Addendum # 004

TENDER NUMBER: 619-CP2003

Renovations and Atrium Project

Our Lady of Fatima Catholic School

DRAWING TITLE
INTERIOR ELEVATIONS - ATRIUM

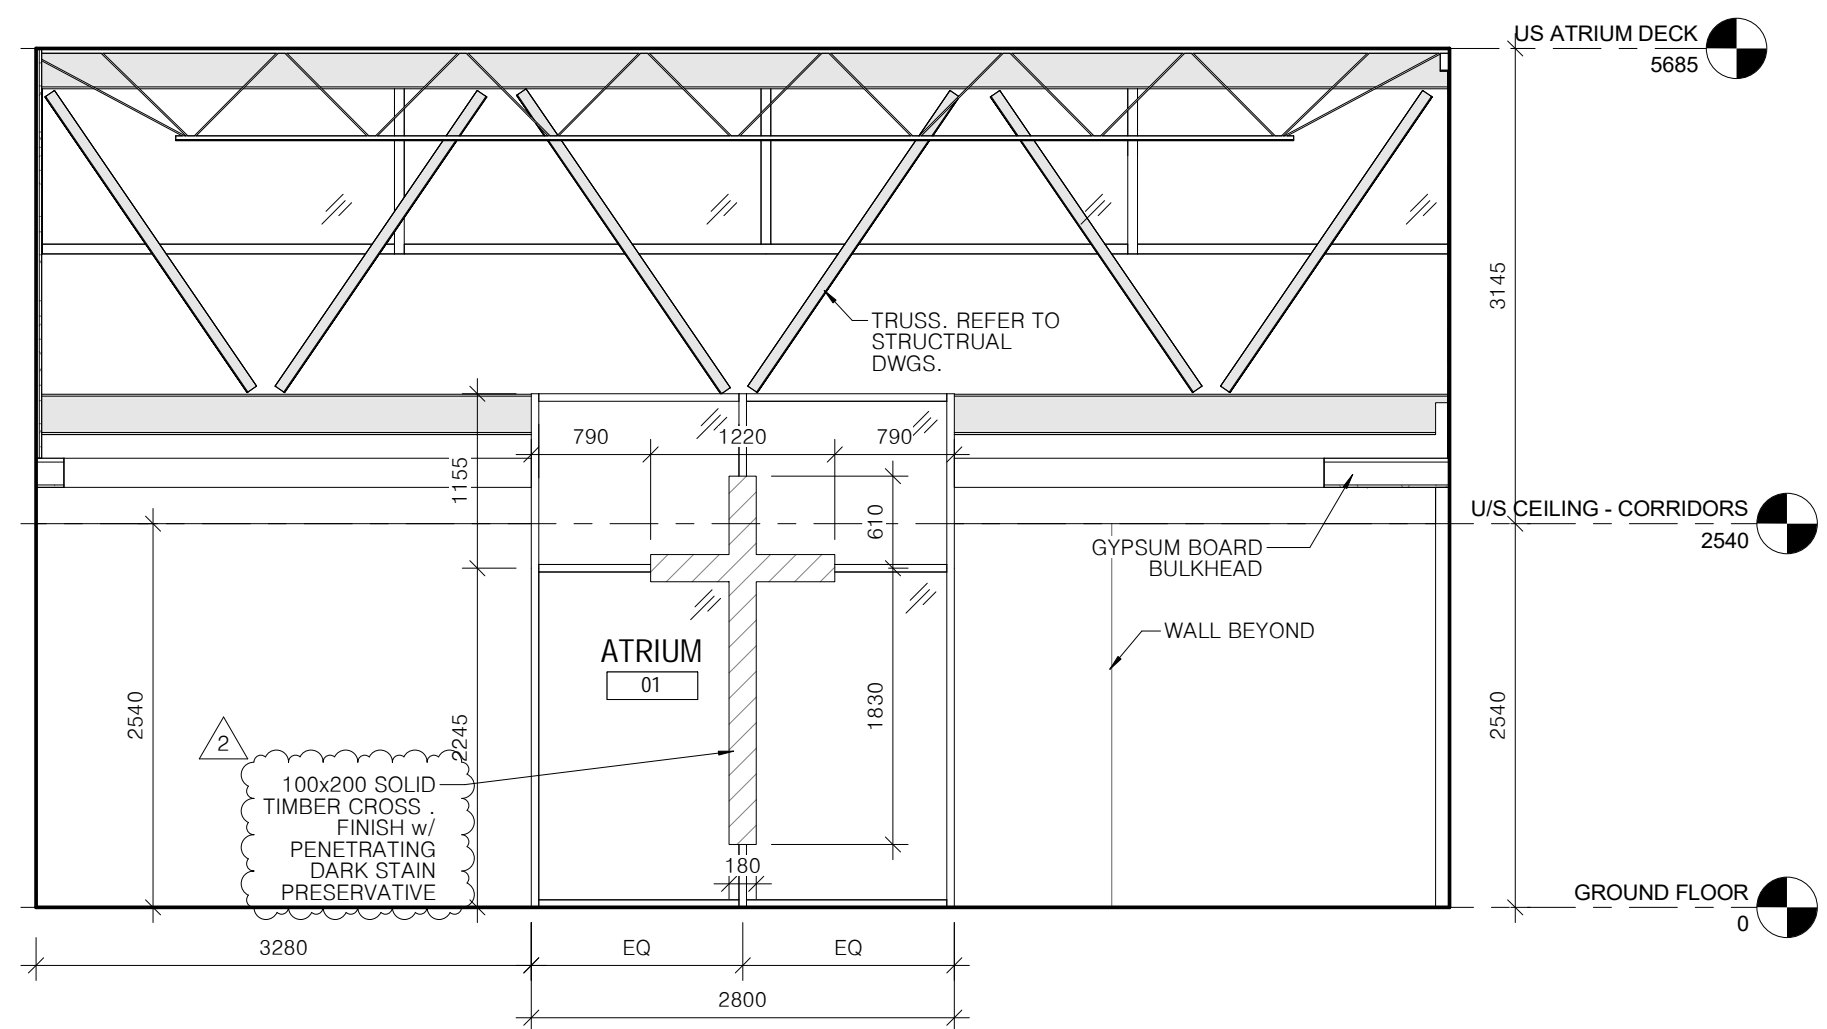
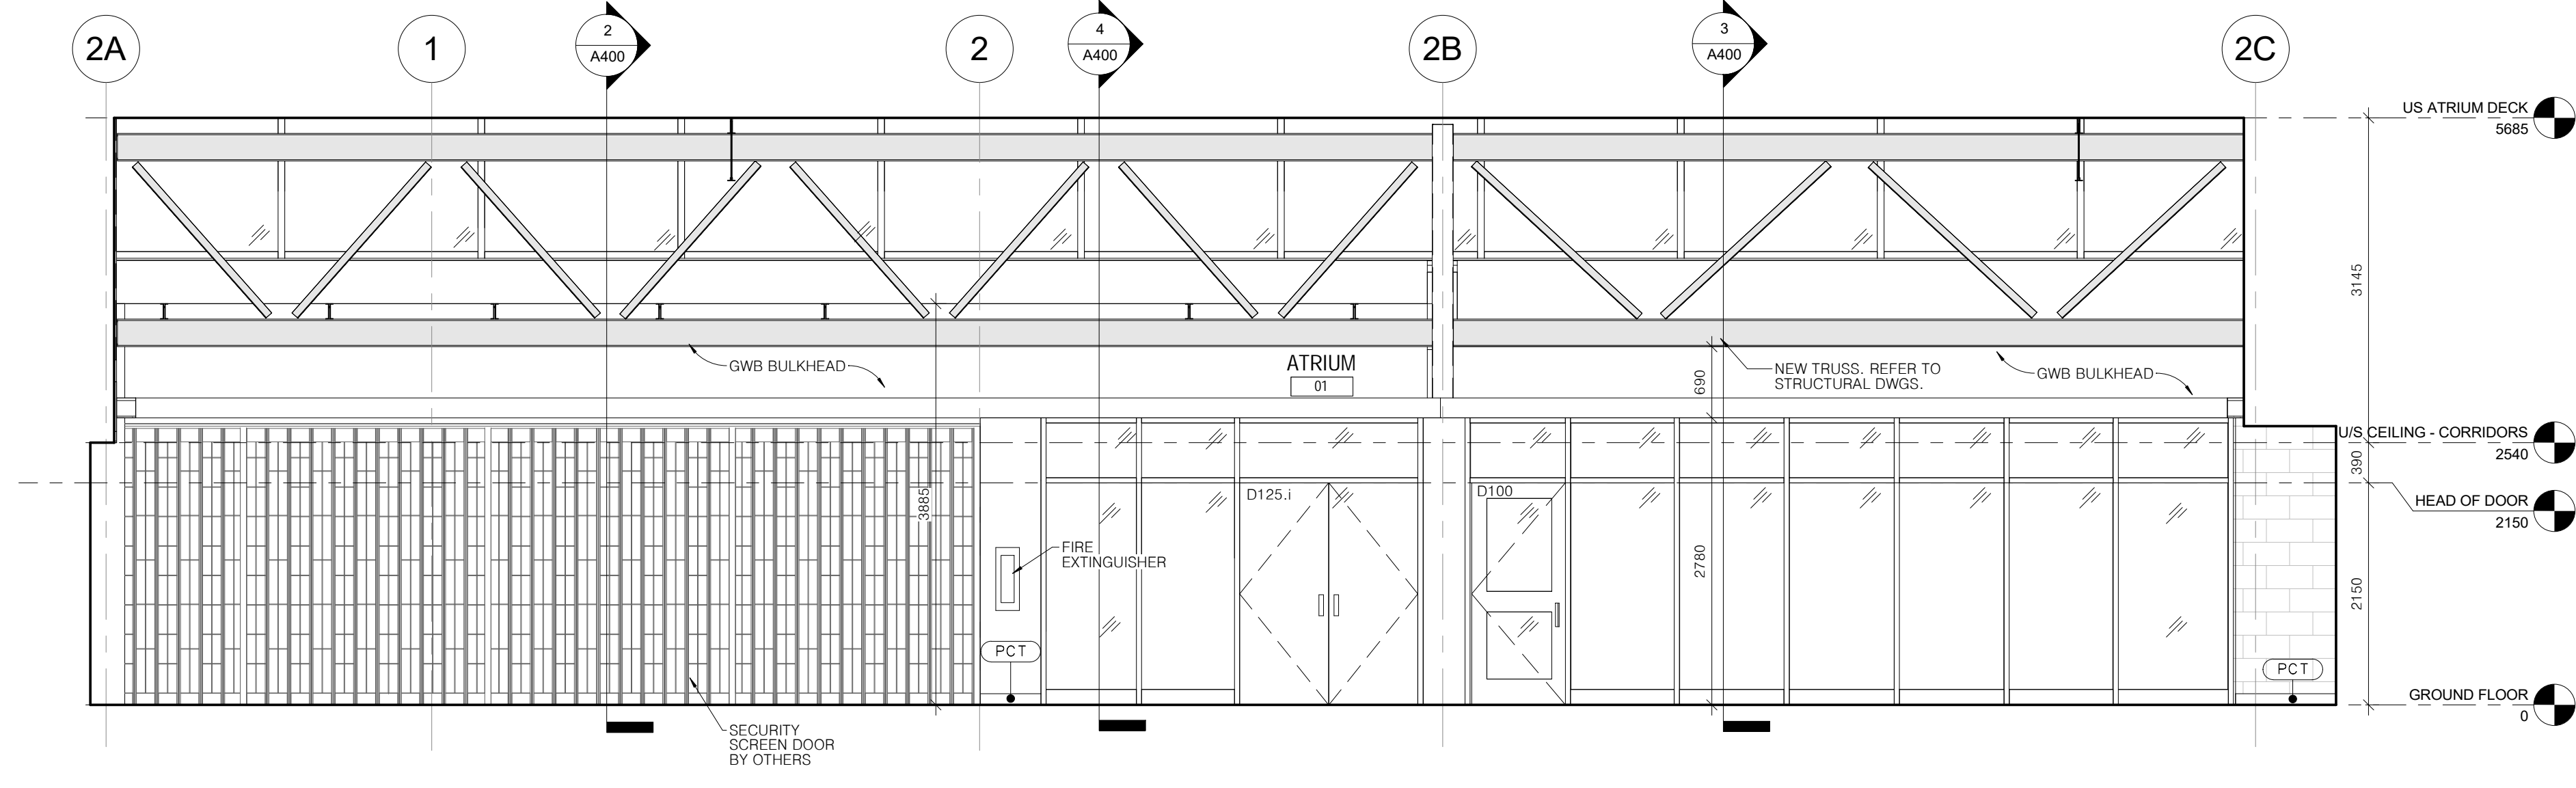
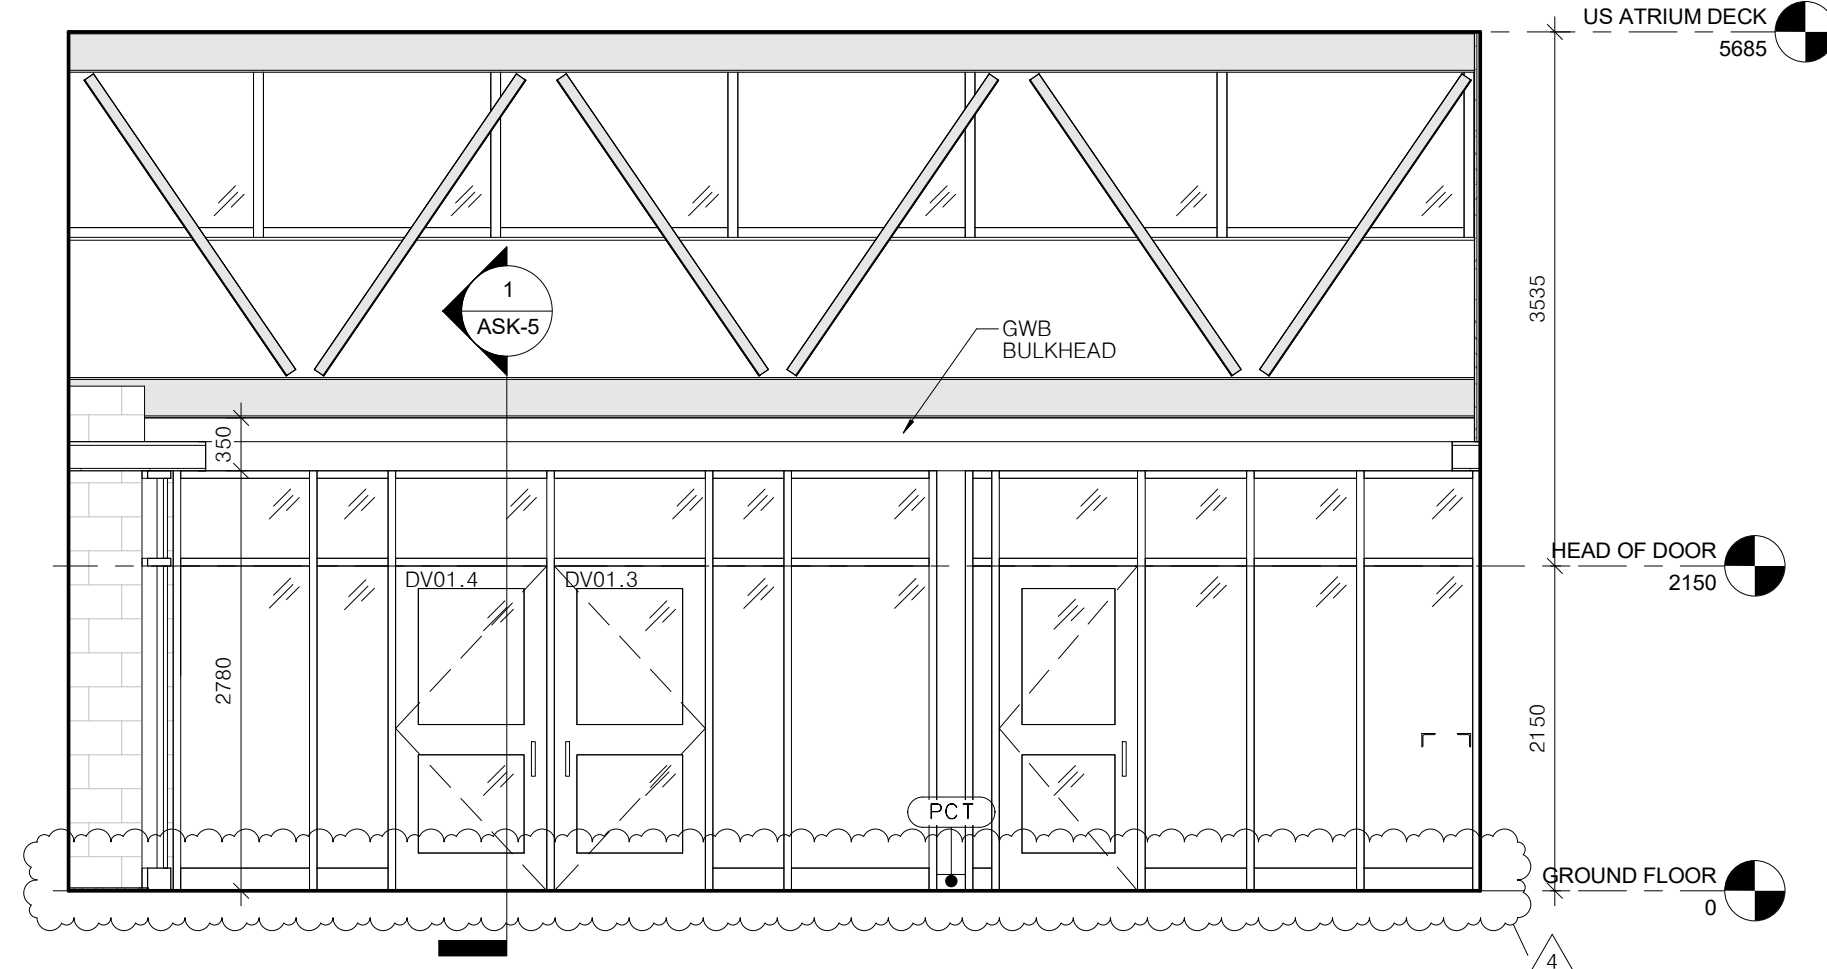
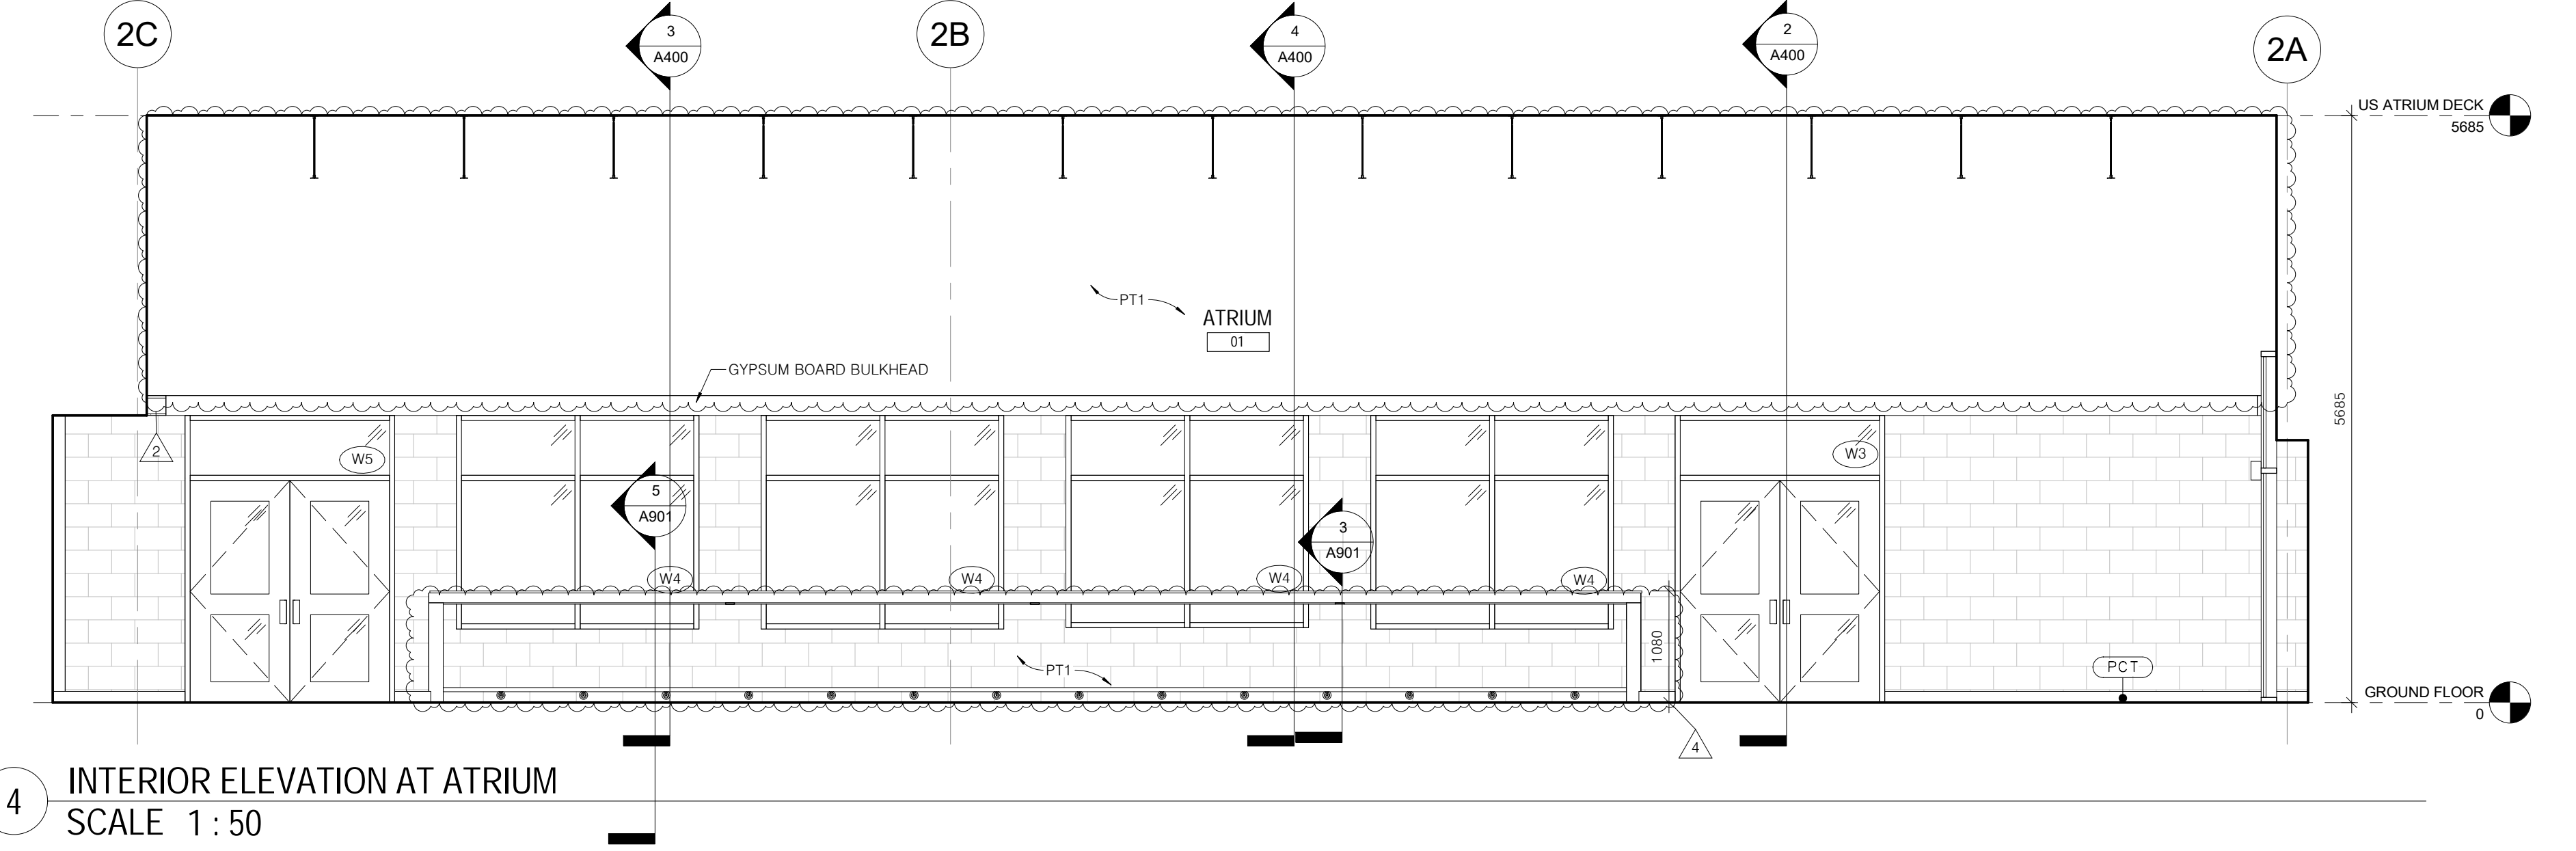
- A10: Cement Faced Insulation is not required for this project
- Q11: Is there a specification for the Cross that was added to the East Elevation other than the note pointing at it? Can a detail be provided showing dimensions, mounting details, type of timber, etc.? [DWG A300]

- A13: Door Schedule is revised to delete “Alternate Price”.
- Q14: The drawings indicate the sliding security screen by others. The spec section indicates it is in contract for GC. Does spec section 08 35 00 refer to the security screen at Col. Line B2 in the opening to the Learning Commons? If yes, Is it by others? If no, please indicate the location for the Sliding grilles in this spec section. [08 35 00 DWG 10/A651, 2/A803]

- A11: Refer to Addendum drawing A803 Detail 1/A803 for details. Also refer to drawing A1002 and elevation 16/A1002. For this detail the cross construction and dimensions are the same as detail 1/A803. Wood Species is to be based upon clear dimensional Western Red Cedar: Grade – select. The contractor is to carry the cost of connection details to be coordinated and engineered by the Aluminum Window Framing system contractor. Final detail to be confirmed in shop drawing process.

- A14: The sliding metal screen as specified is along Gridline B between the Atrium and learning commons and is to be included in bid/contract. Drawing detail 10/651 and 2/A803 are revised to delete note: “security screen by others”

REVISION TO DRAWING M101.4

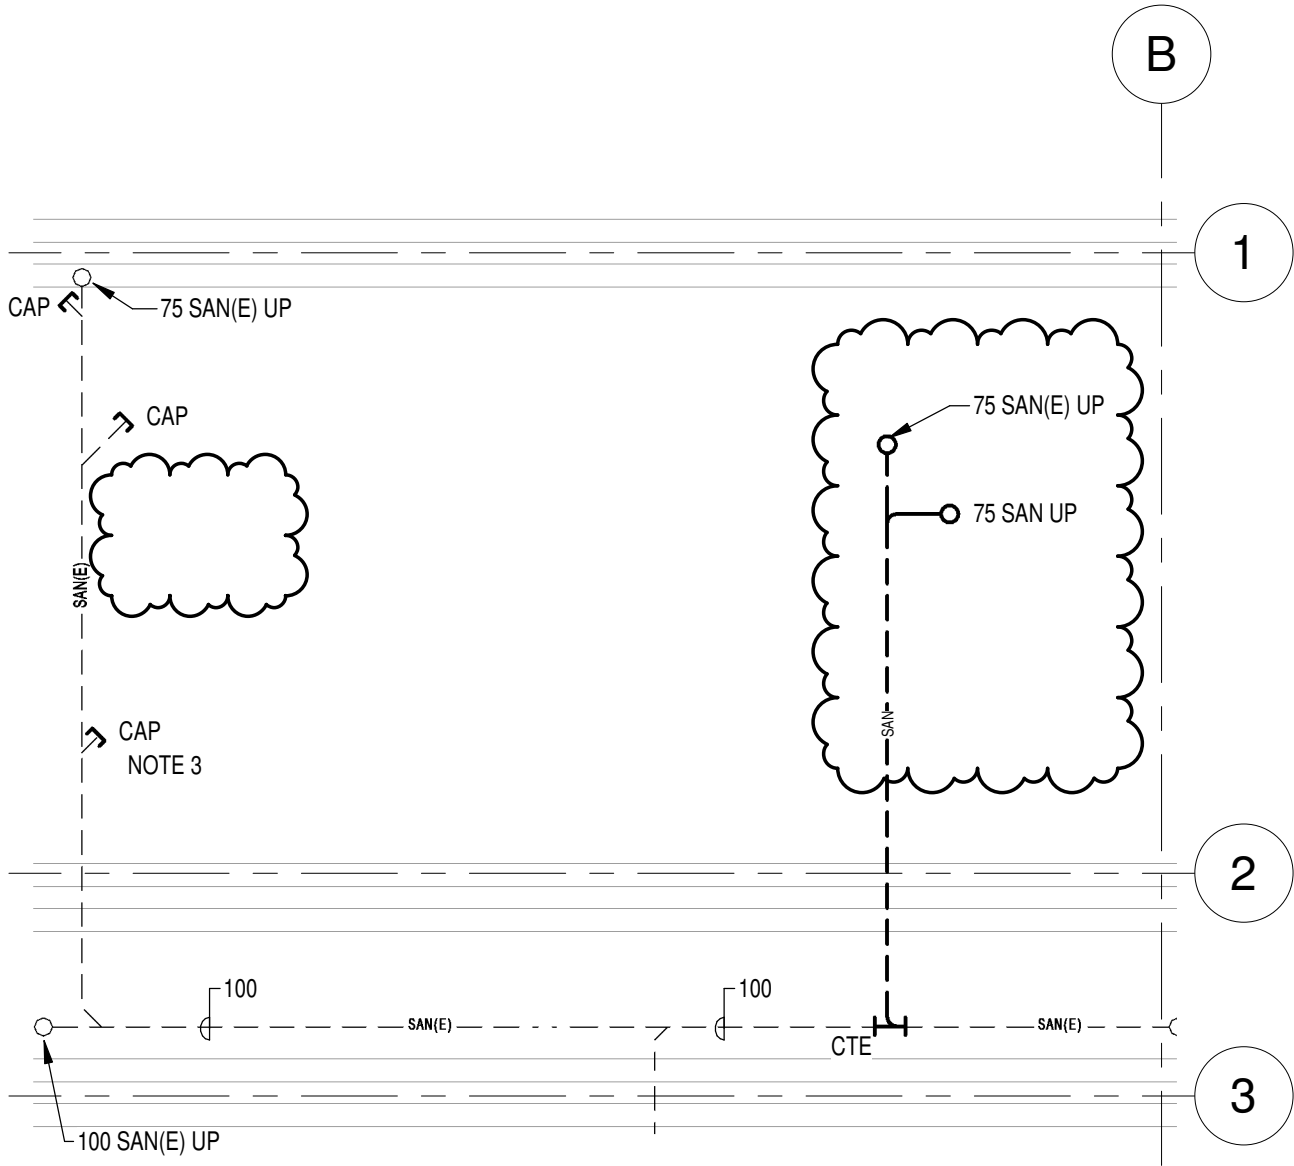
1. Drawing M101.4 - Mechanical Legend, Abbreviations and Drawing List

1. Refer to revision drawing MR-1, attached.
